**ADDENDUM NUMBER TWO**  
TO THE CONTRACT DOCUMENTS FOR CONSTRUCTION OF  
**ORANGE BEACH RECREATION COMPLEX**  
**NEW BASEBALL/SOFTBALL FIELD RENOVATIONS AT ORANGE BEACH SPORTSPLEX**  
CITY OF ORANGE BEACH

This addendum forms a part of the Contract Documents and modifies the Bid Documents dated May 4, 2020.

LS001

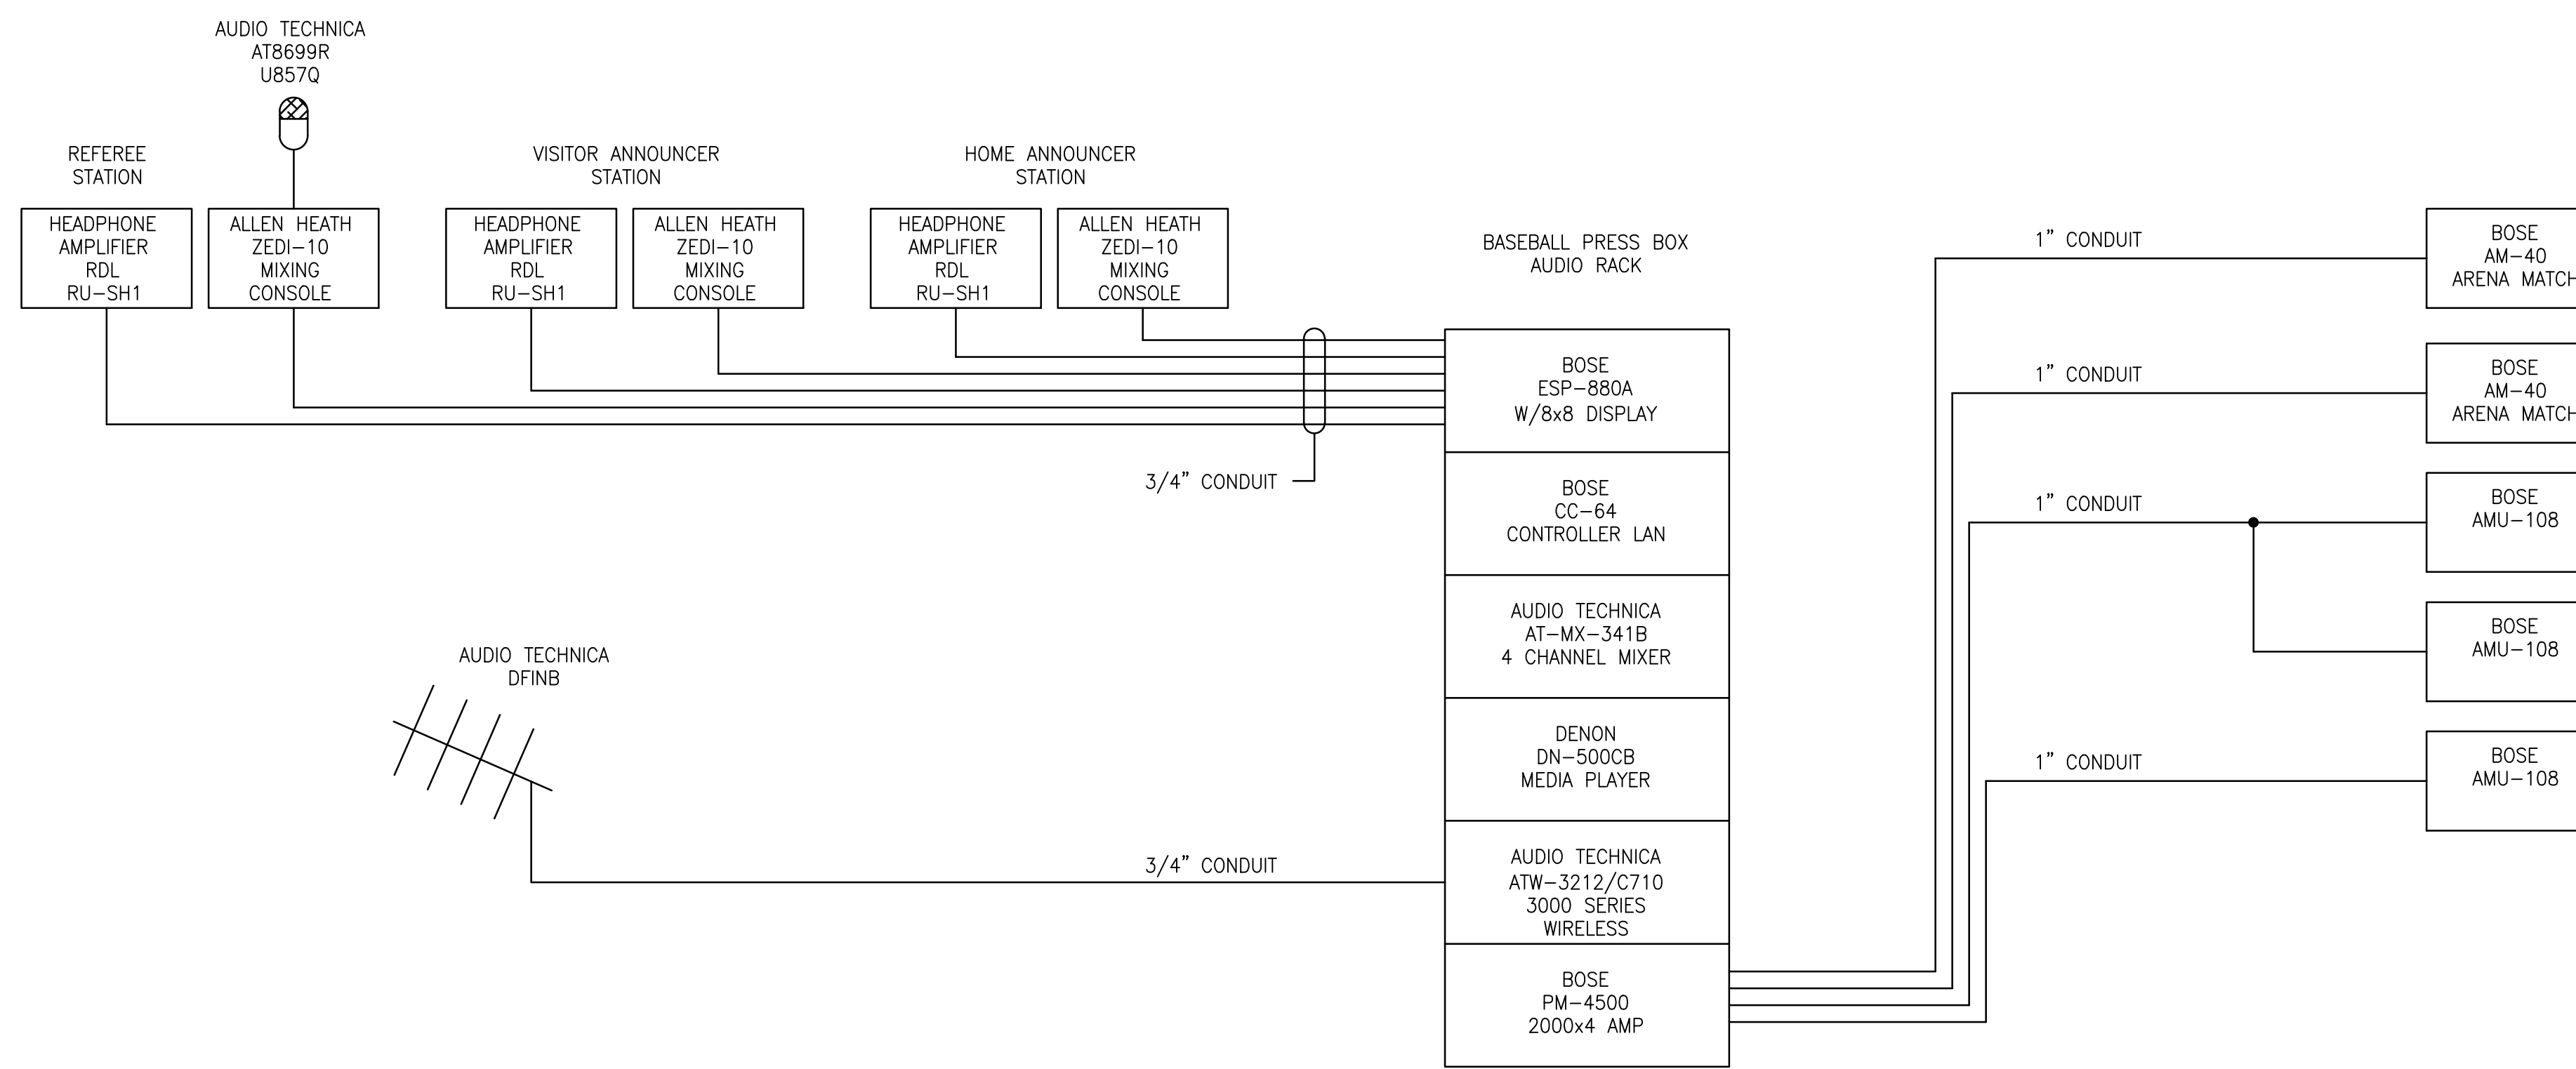
ITEM 01      SHEET LS001 – CODE STUDY  
**Reissue Sheet** in its entirety.  
1. Revised notes and code references.  
    a. Manual Fire Alarm System not required.  
    b. Egress Width of A-3 shown consistently as Non-Sprinkler building.  
    c. Egress Exit and Exit Access requirements for the IBC and ICC.  
2. Added the ICC-300 to the applicable code list.

DRAWING NO: E500

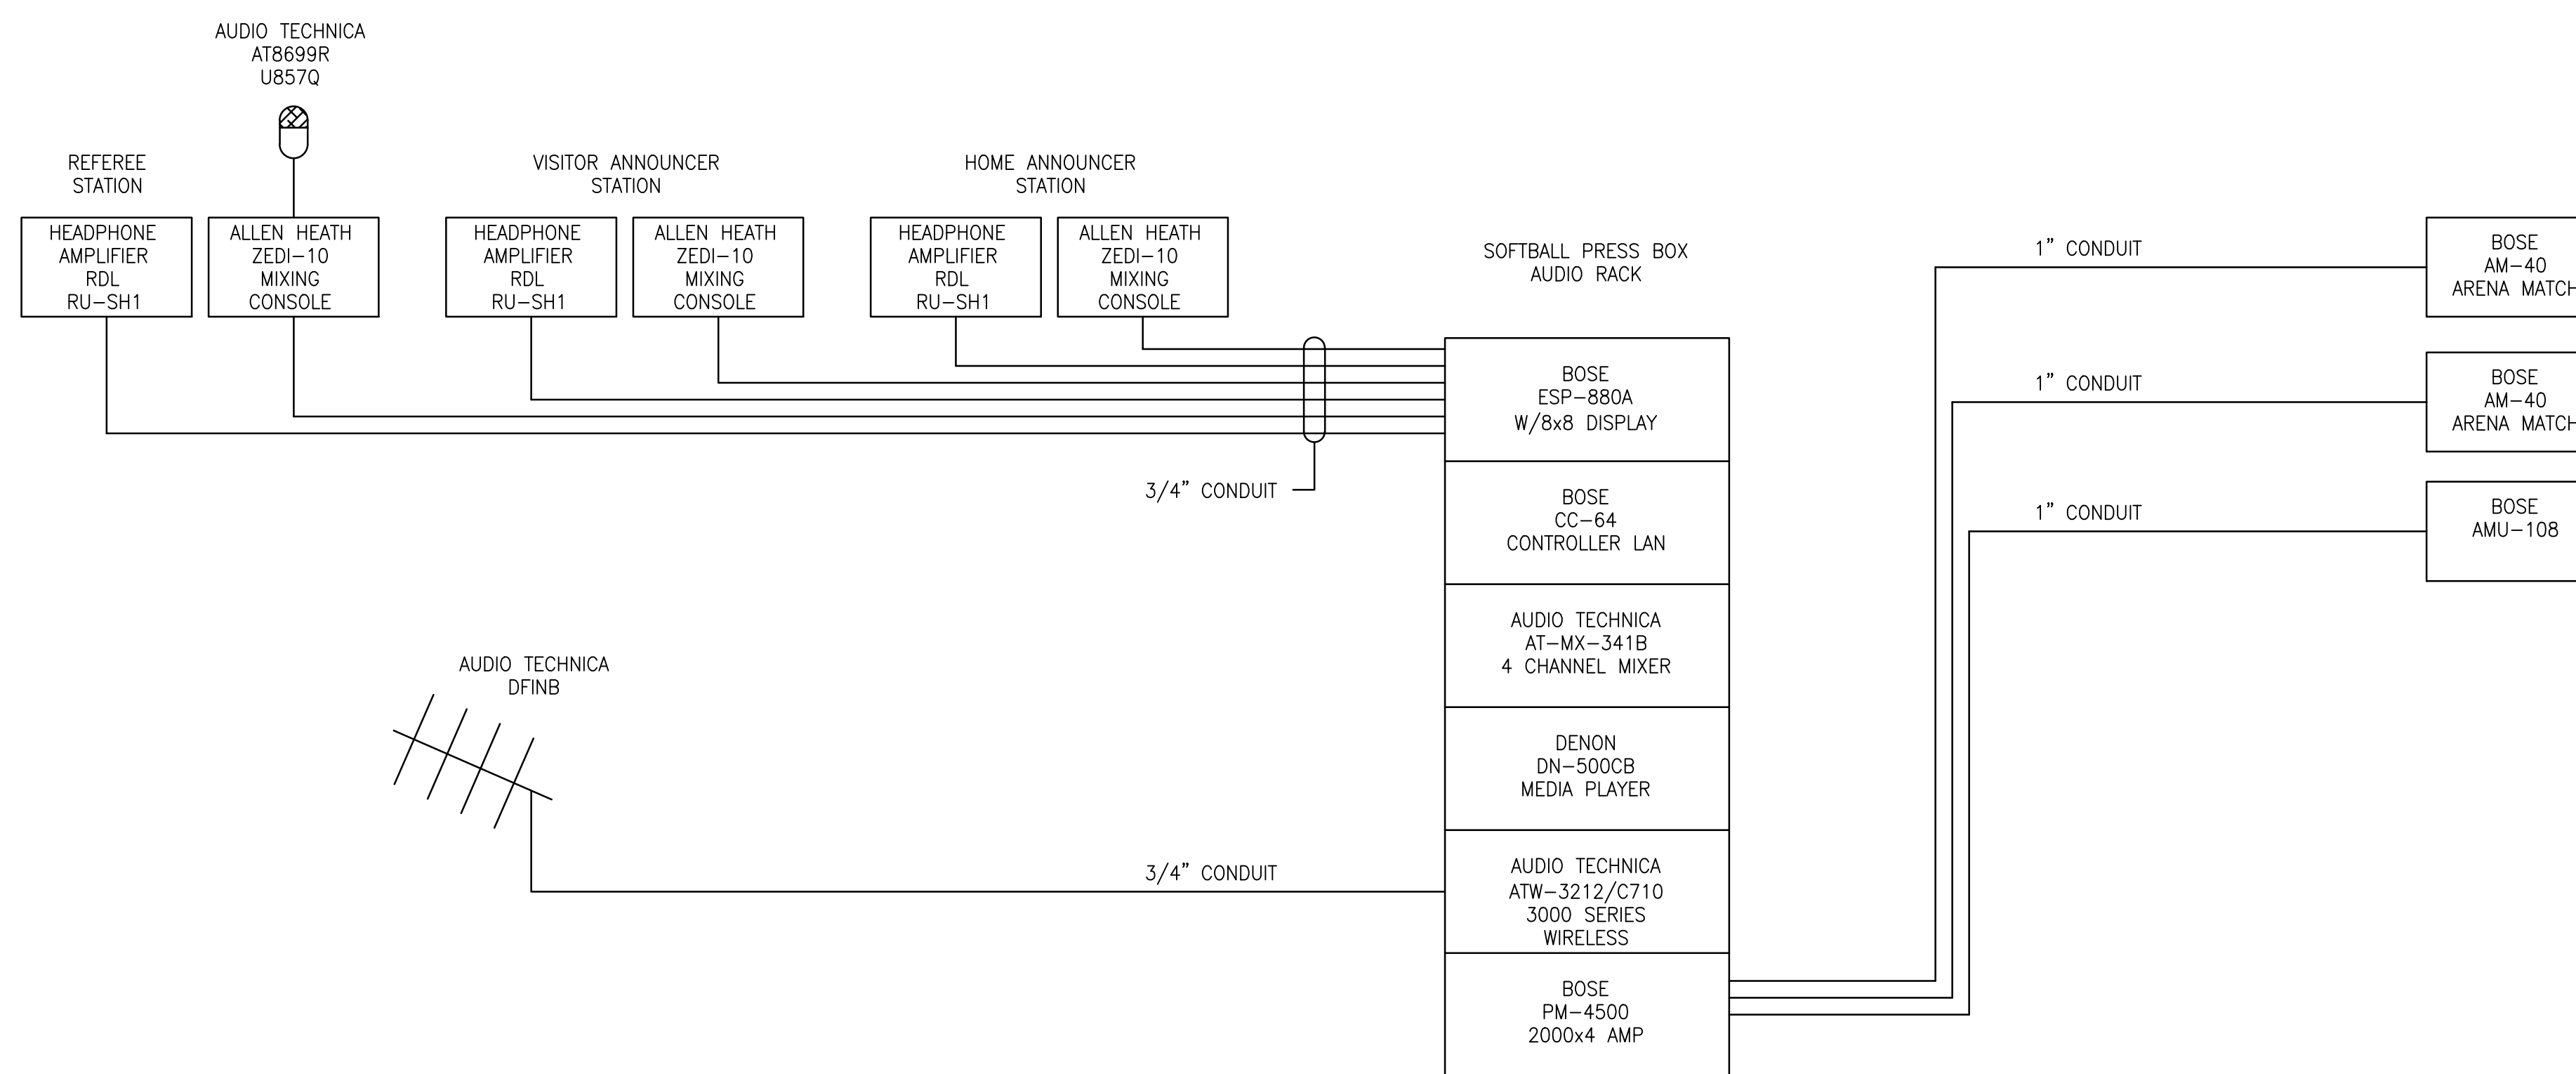
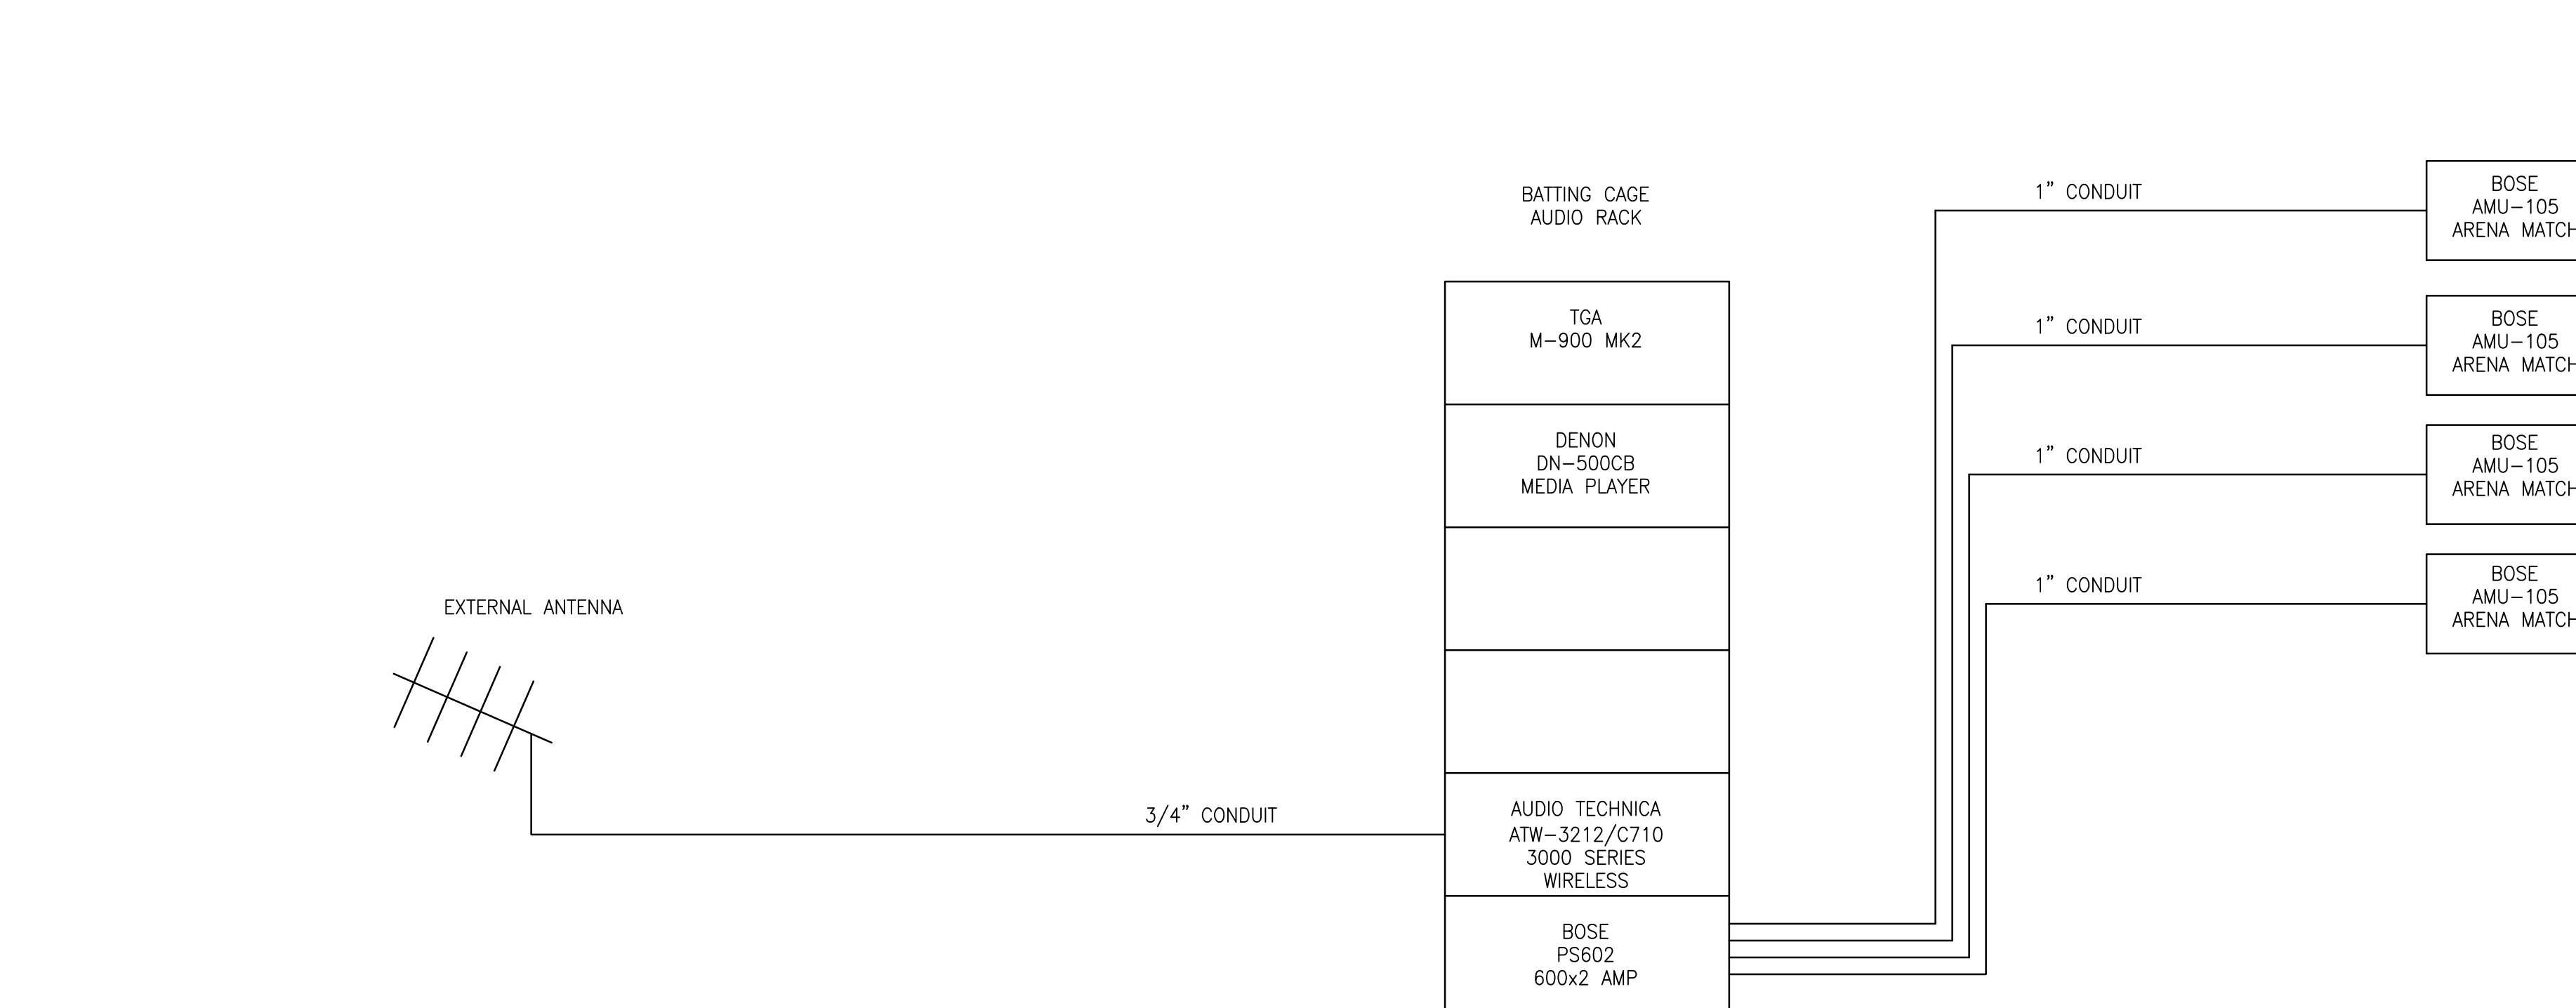
ITEM 03      SHEET E500 – AUDIO RISER DIAGRAM  
**Reissue Sheet** in its entirety.  
1. Revised Note 2 with updated equipment rack type.  
2. Removed/Omitted Note 3
